CITY OF LAKE WORTH BEACH

New Business Item A

PZB 20-00500003: Request by Anne-Christine Carrie of KEITH on behalf of 1900 10th Ave, LLC for consideration of a:

to construct Vehicle Fueling/Charging Station, Single-Destination Retail, and Restaurant uses at 1900 10th Avenue North within the Mixed-Use West (MU-W) zoning district.

Landscape Plan

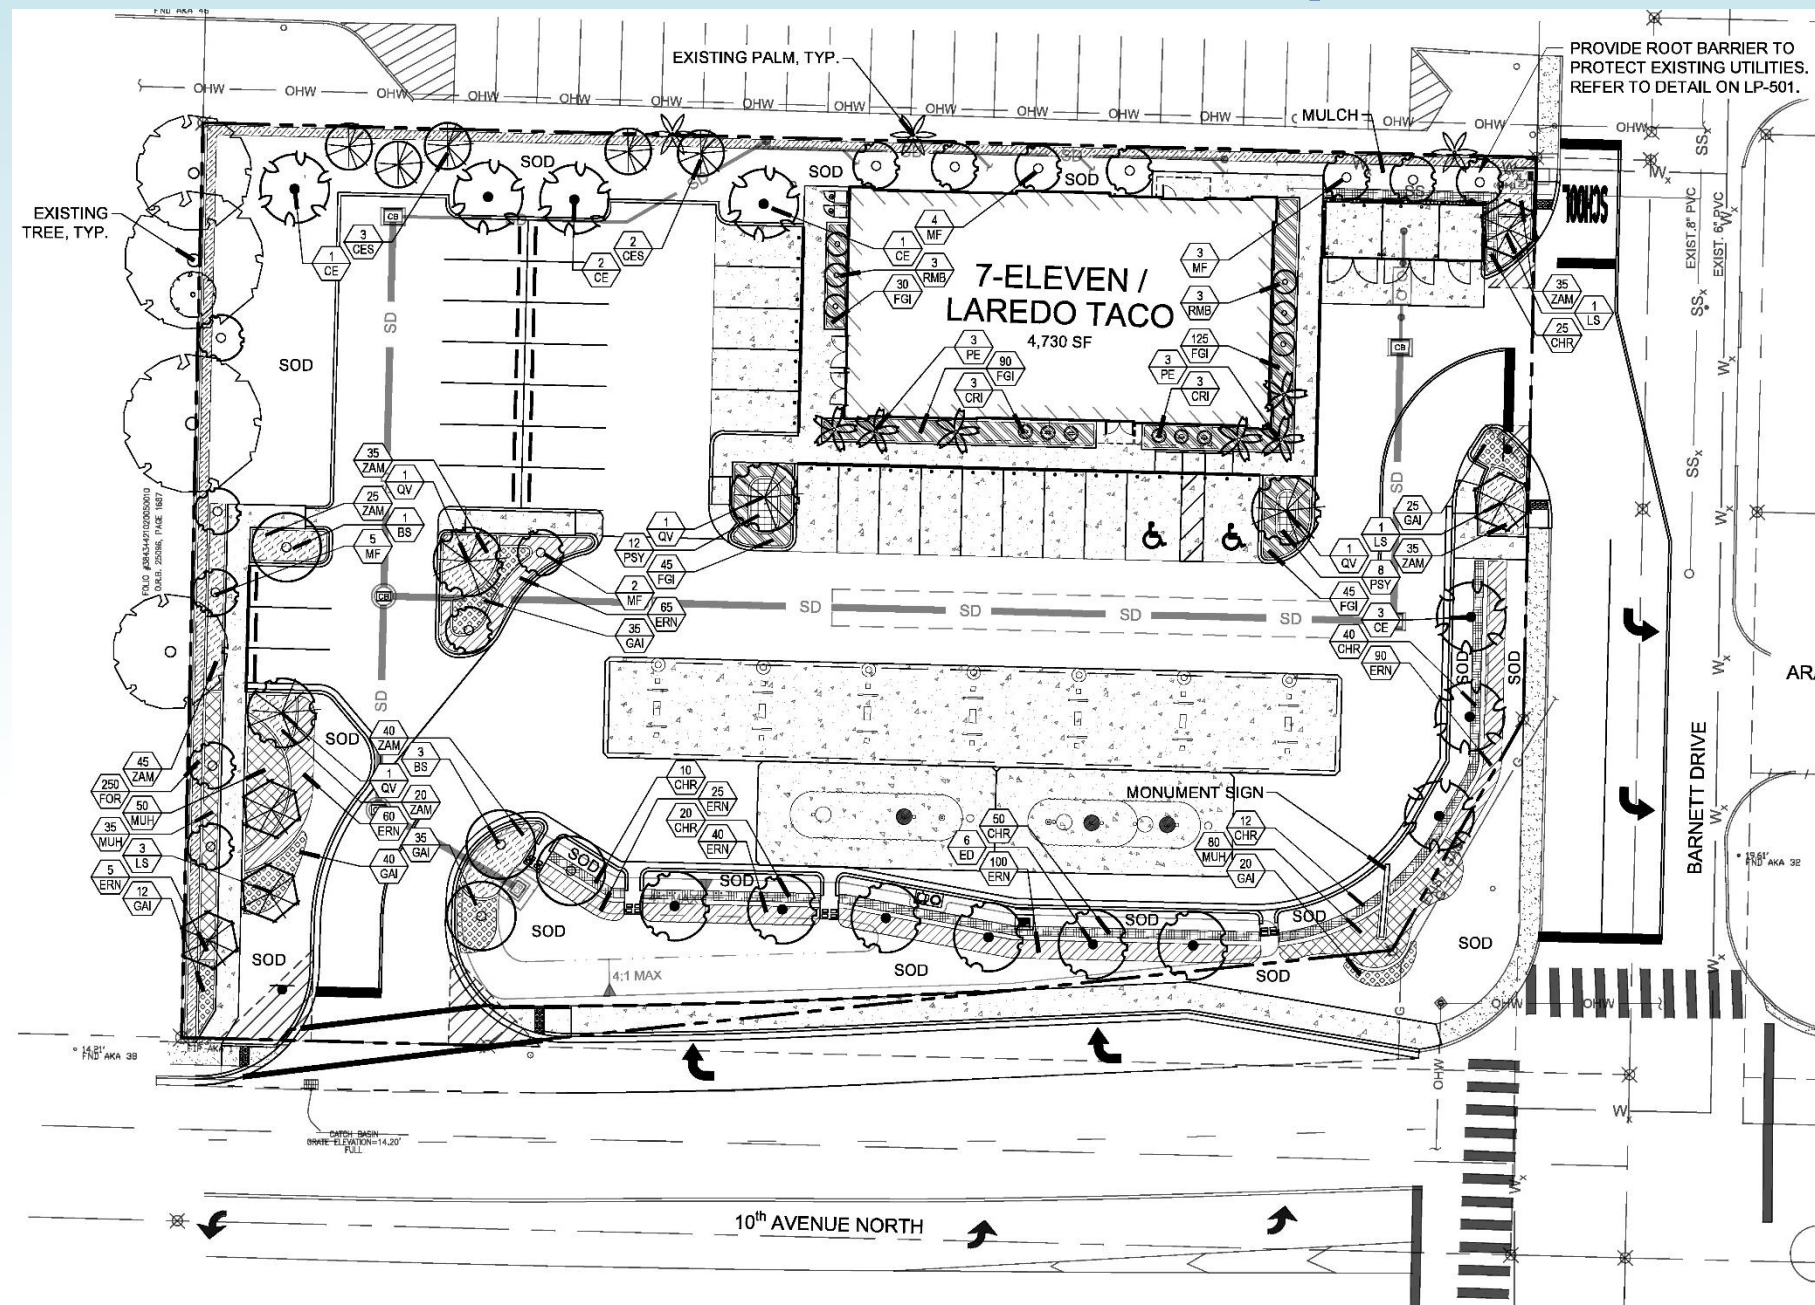
1. The landscape screen adjacent to the air/vac mechanical equipment along 10th Avenue North shall be maintained at a height of at least $\frac{3}{4}$ of the height of said equipment so that it is screened from the right-of-way.

Elevation (South Façade)

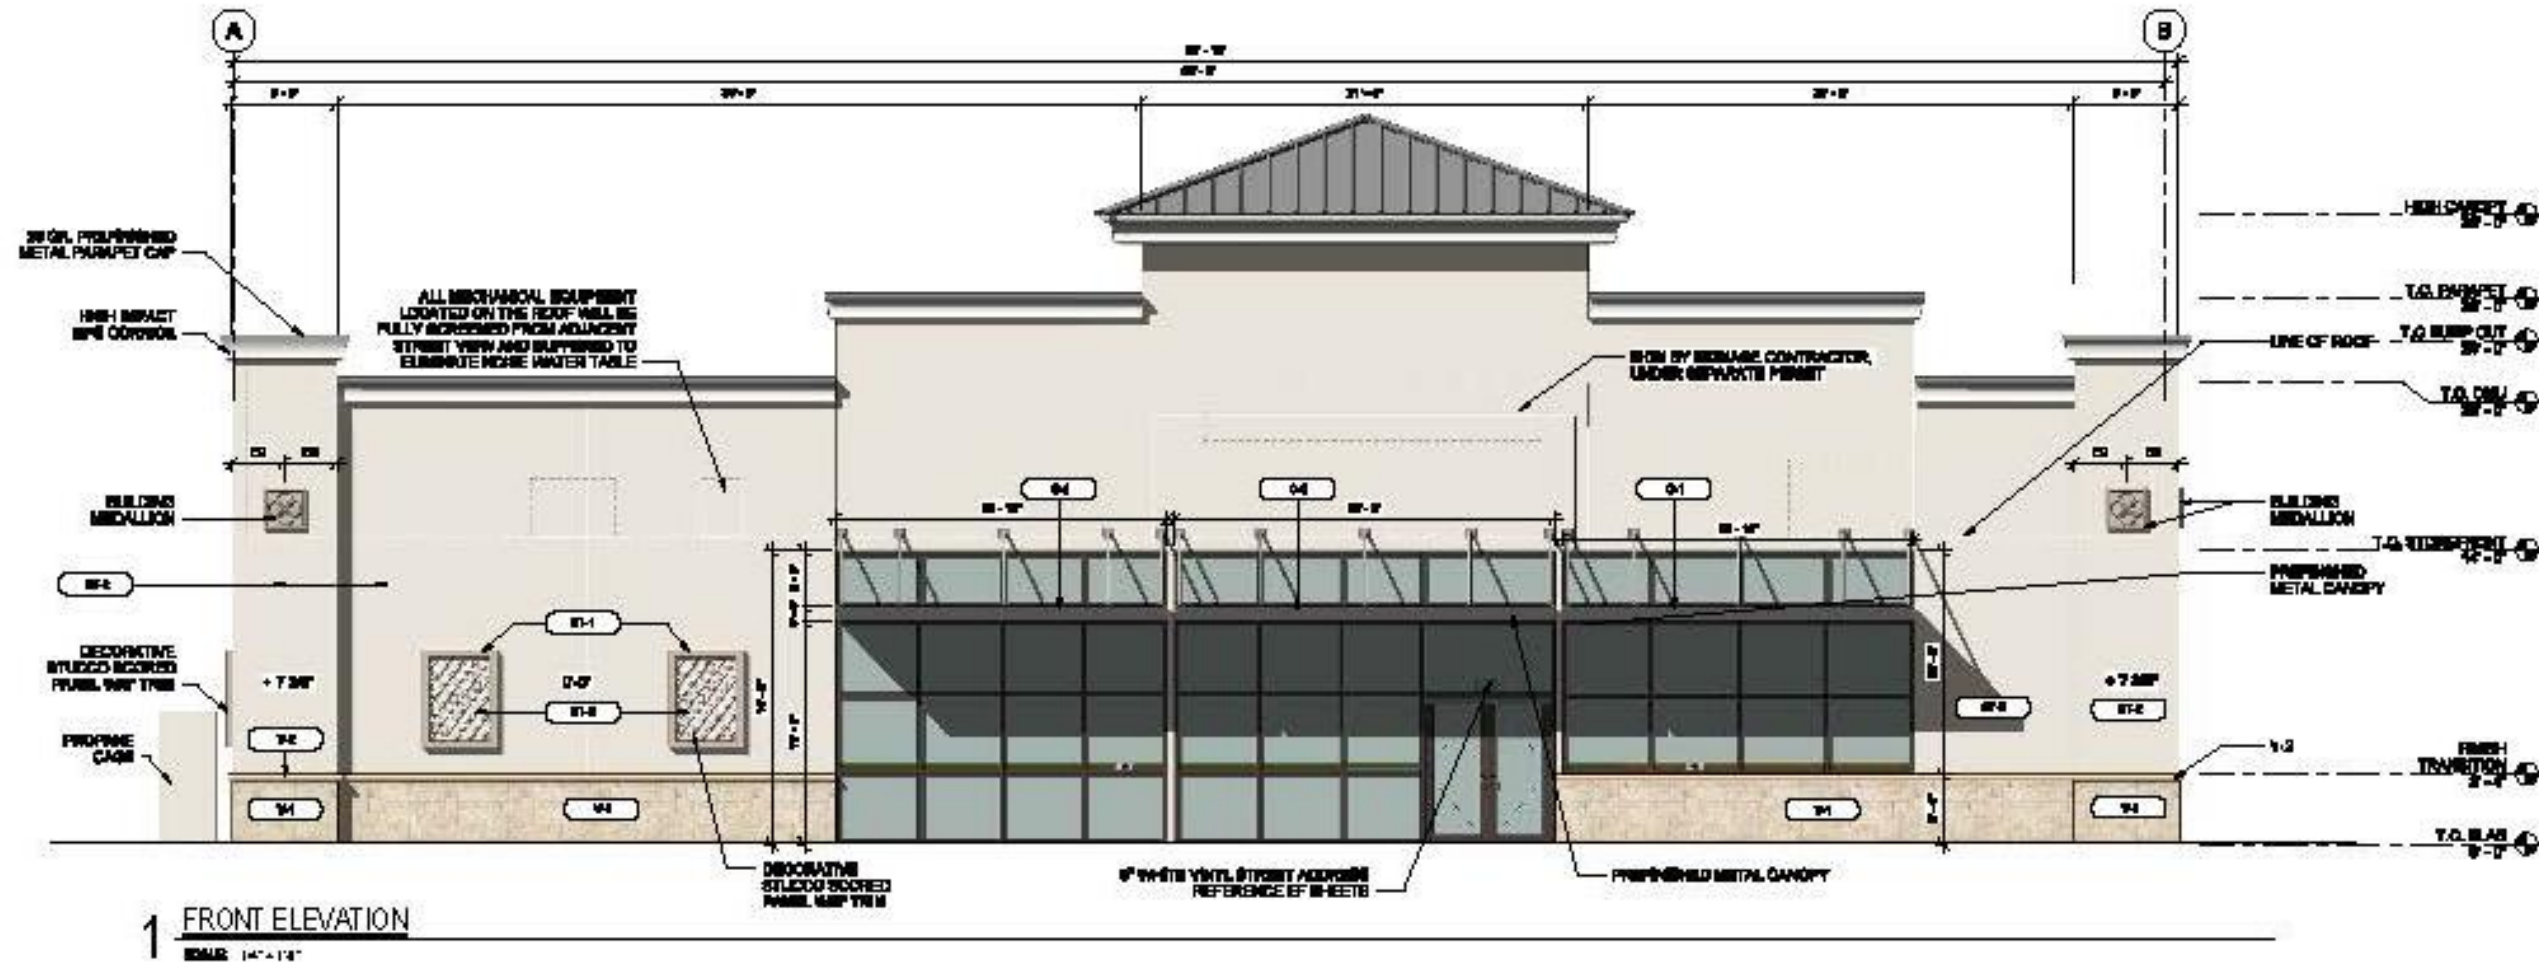
3. There shall be no outdoor display of any kind of merchandise.
4. Prior to the issuance of a building permit, the following shall be completed:
 - a. Continue the fenestration toward the ground across the entire building on both sides of the entrance doors.

- b. Paint the retail/restaurant building a color other than beige as described in the Major Thoroughfare Design Guidelines; alternative colors and/or materials shall be presented to the PZB for consideration and approval; and architectural plans shall be updated and approved by staff prior to the issuance of a building permit to reflect an alternate color or materials.
